Presentation to Independent Planning Commission

Hills of Gold Wind Farm

February 2, 2024

Brian Tomalin

Representation of a wind farm bearing no relationship to the terrain of the Hills of Gold wind Farm
(Source: **Department of Planning and Environment** dpie.nsw.gov.au
State Significant Development Assessment Report (SSD 9679)
December 2023)

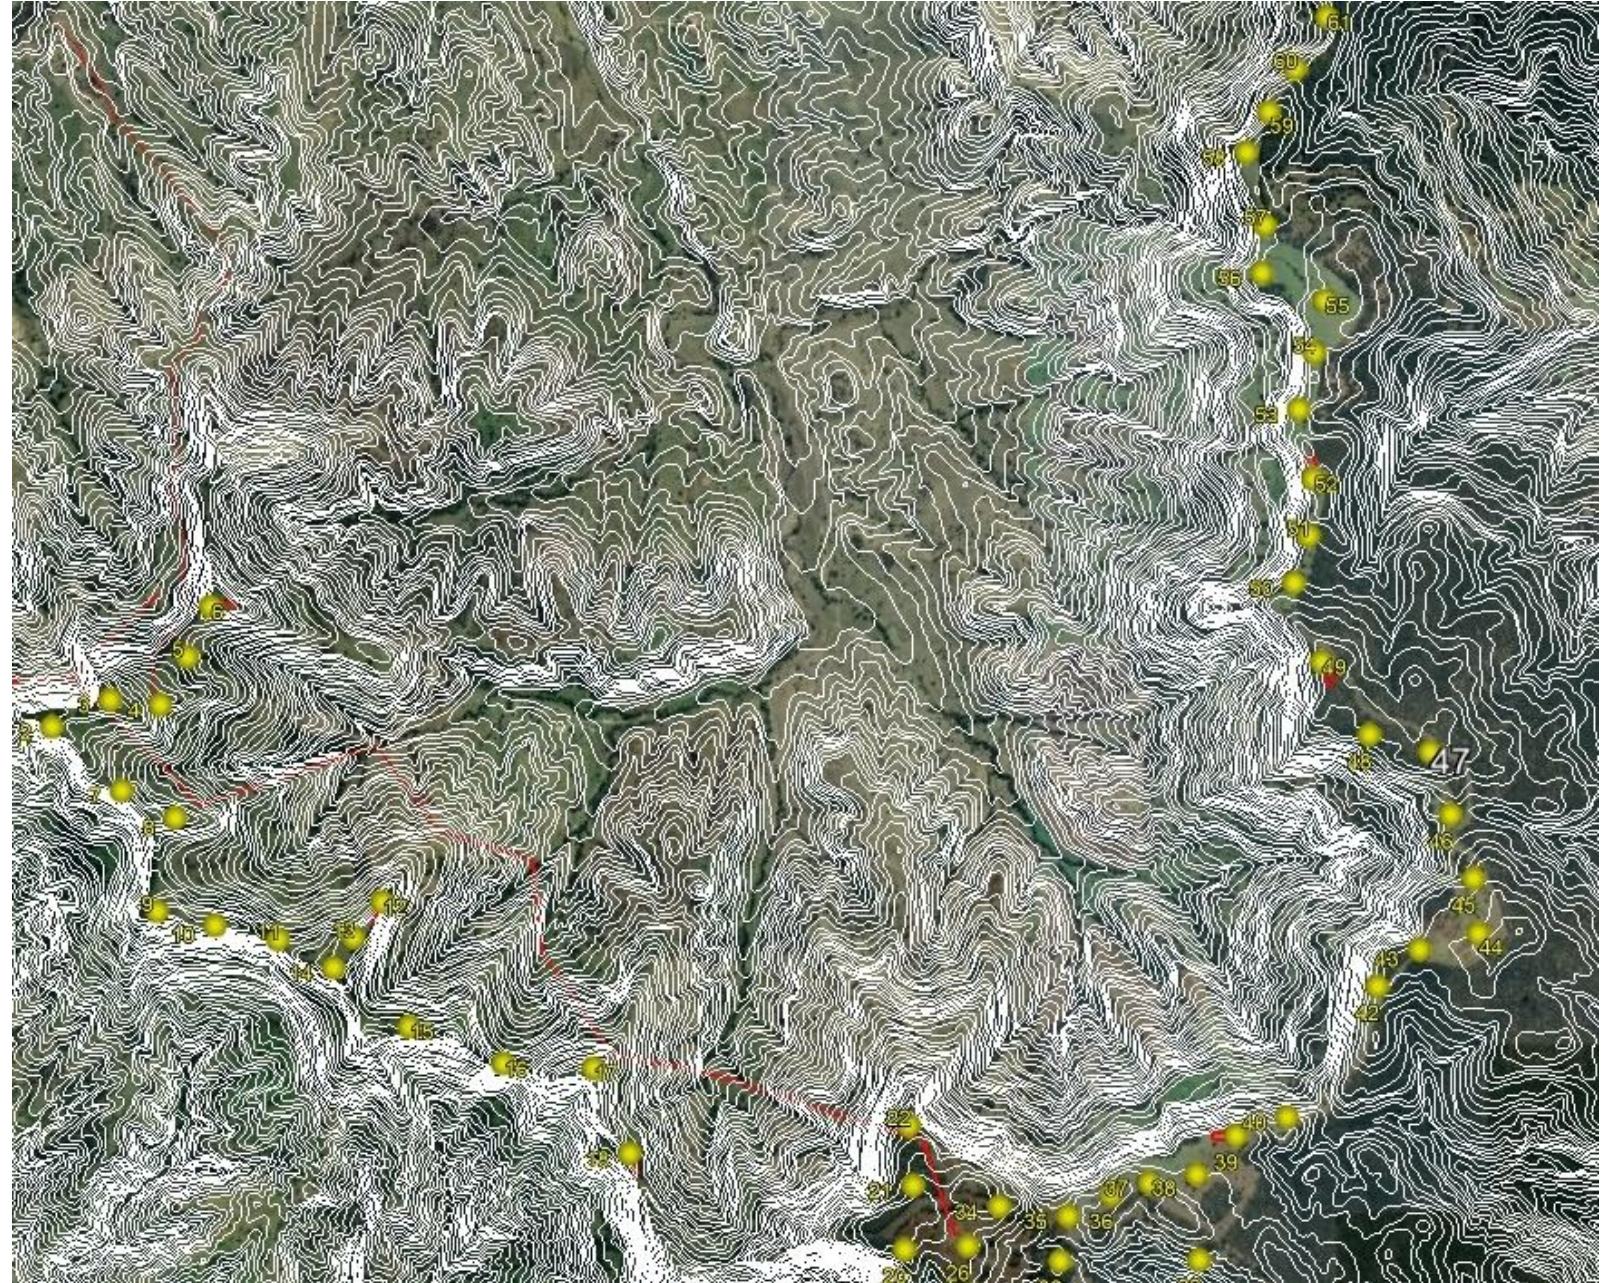
- Essential information not covered
- Rainfall has been underestimated
- Climate change impacts not addressed
- Hydrology not addressed
- Downstream flow impacts not addressed
- Structure of mountain or the impact on ground water not addressed
- Contour maps not used
- Misleading illustrations and examples – not applicable to project location
- Wider or regional environmental impacts not considered
- Site specific engineering not developed
